Staff Report for PLCUP-2603-0007

Application Type: Concurrent Use Permit

Location of Subject: 1712 W 3rd St

The applicant is seeking a concurrent use permit for construction of a replacement deck and stairs to provide code compliant access to residential units.

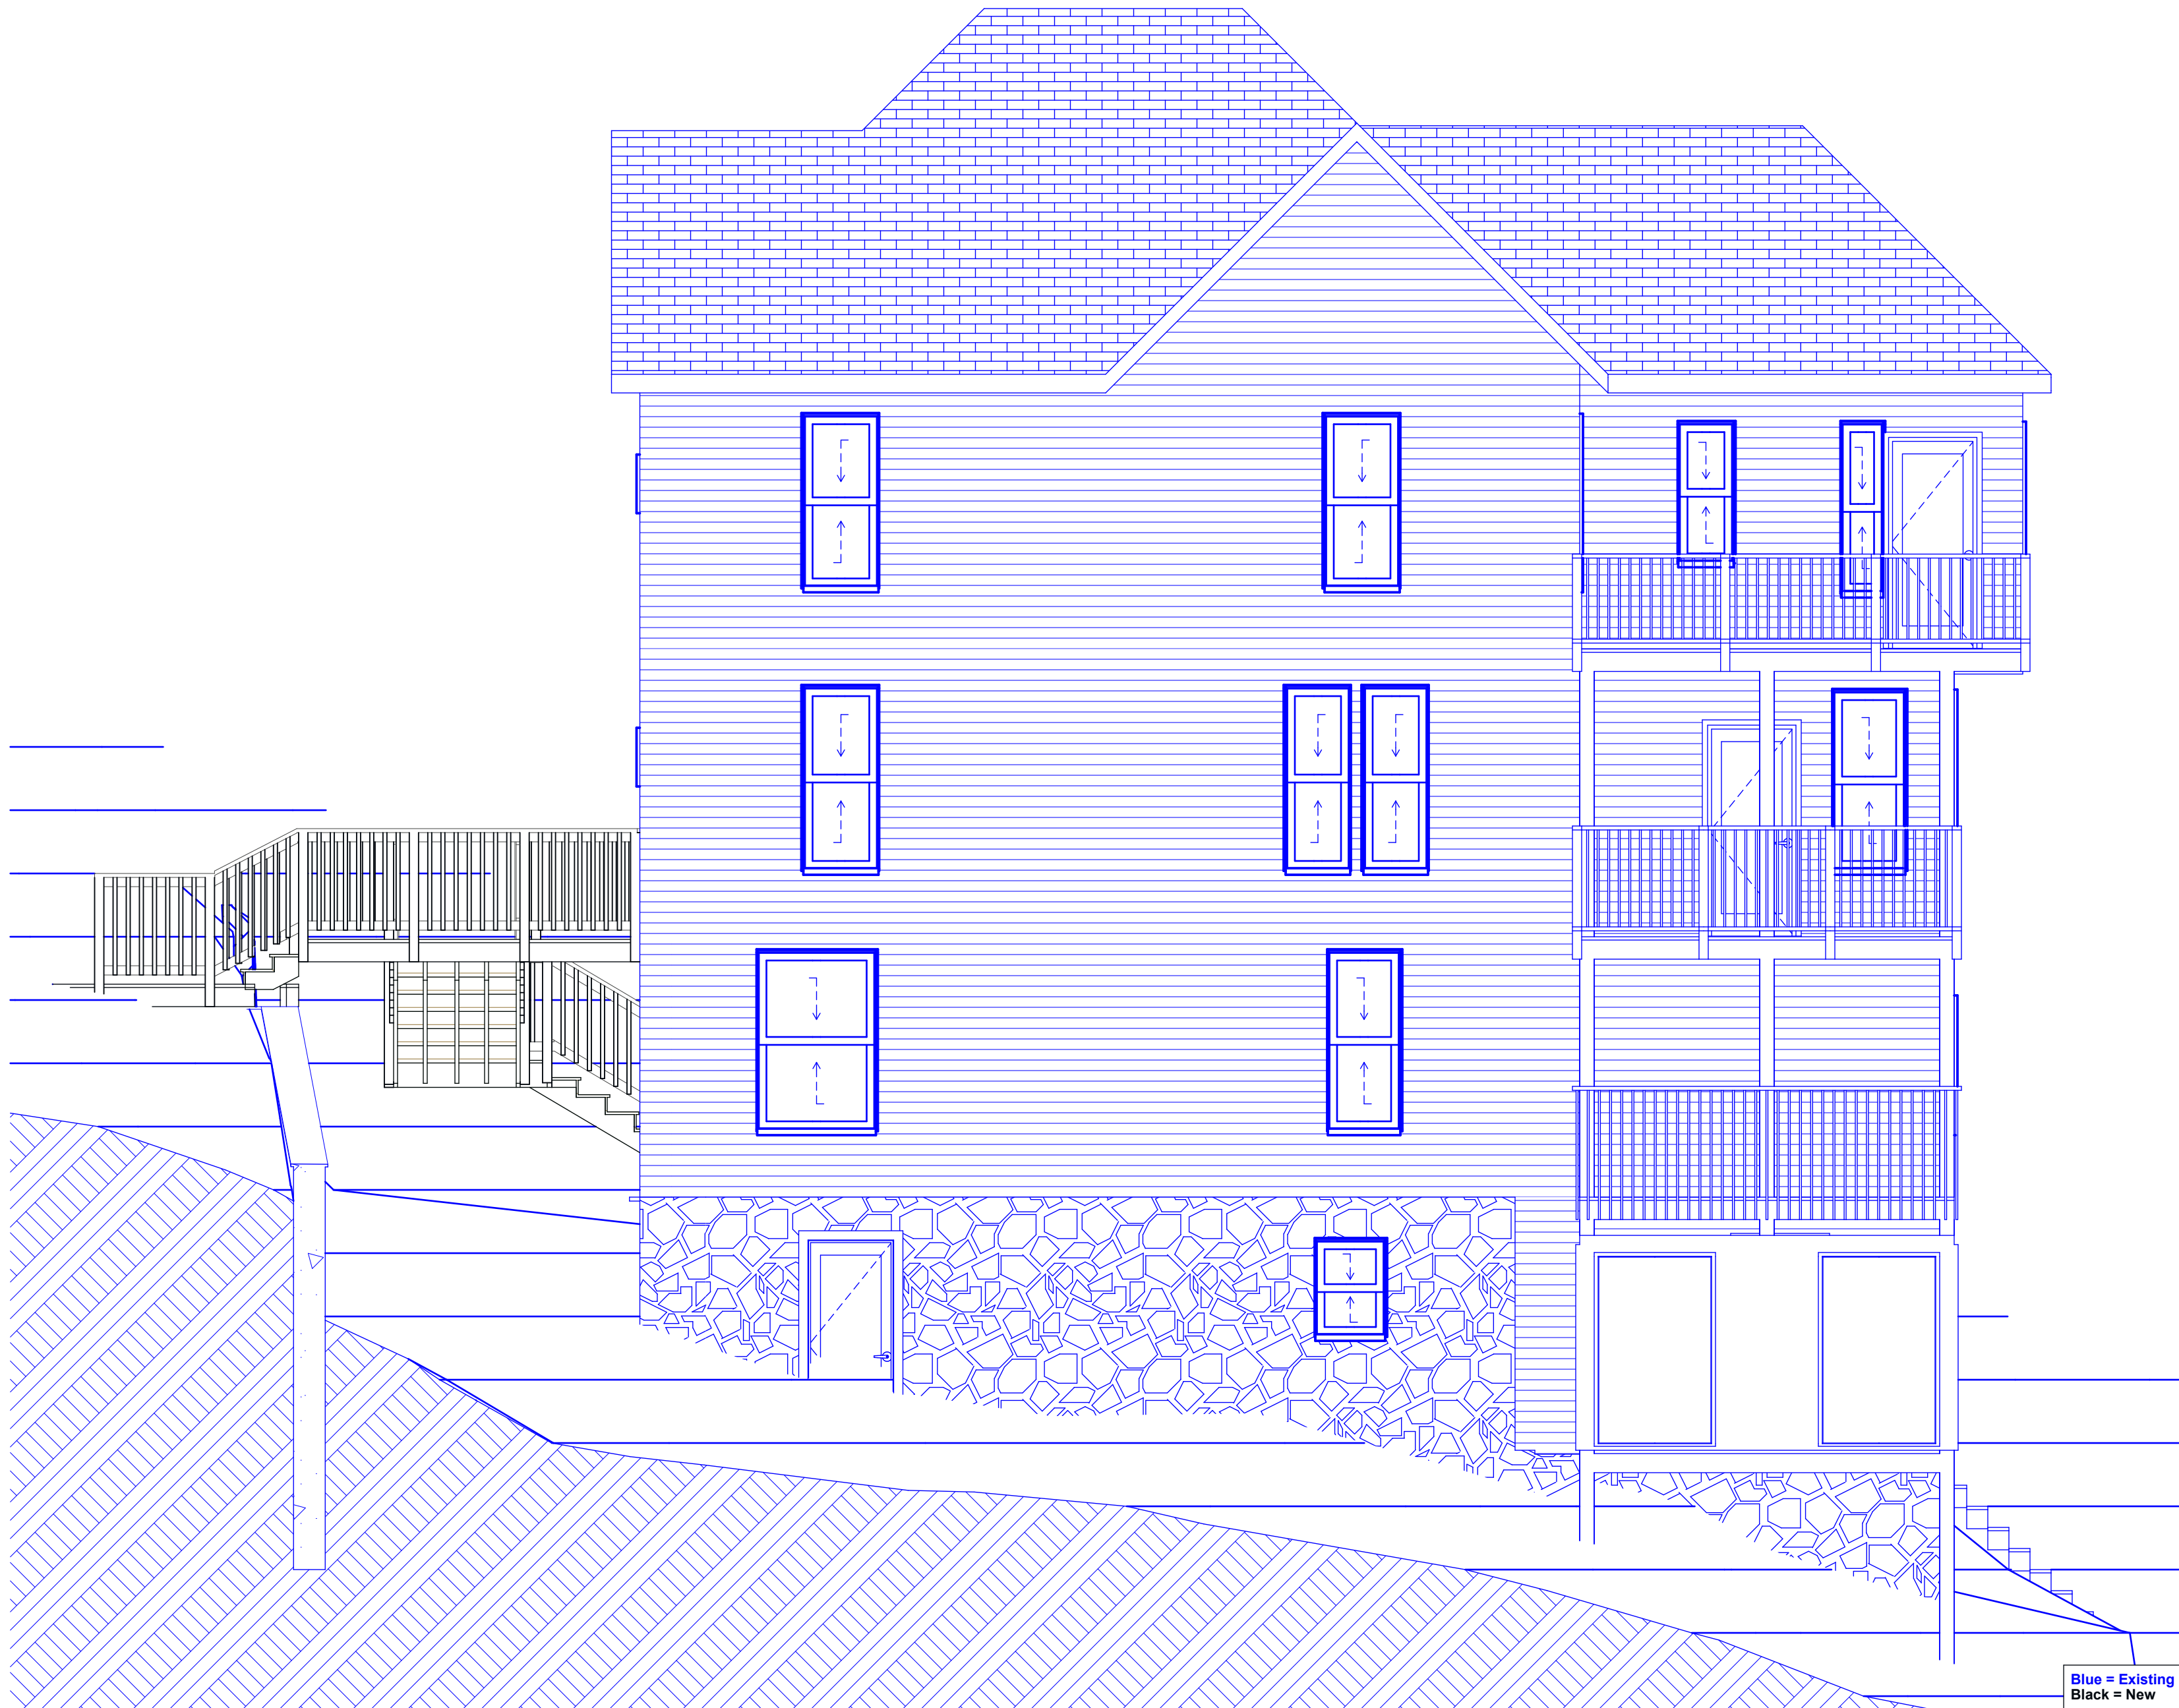
6. One comment was received from Engineering, asking whether a handrail is proposed to extend into the sidewalk. Design elements will be reviewed during the building permit review. No other City, agency, or public comments were received.

Ok, I see the survey, but it references the concurrent use drawing. All I want to know is there going to be railing extended into the sidewalk or not.
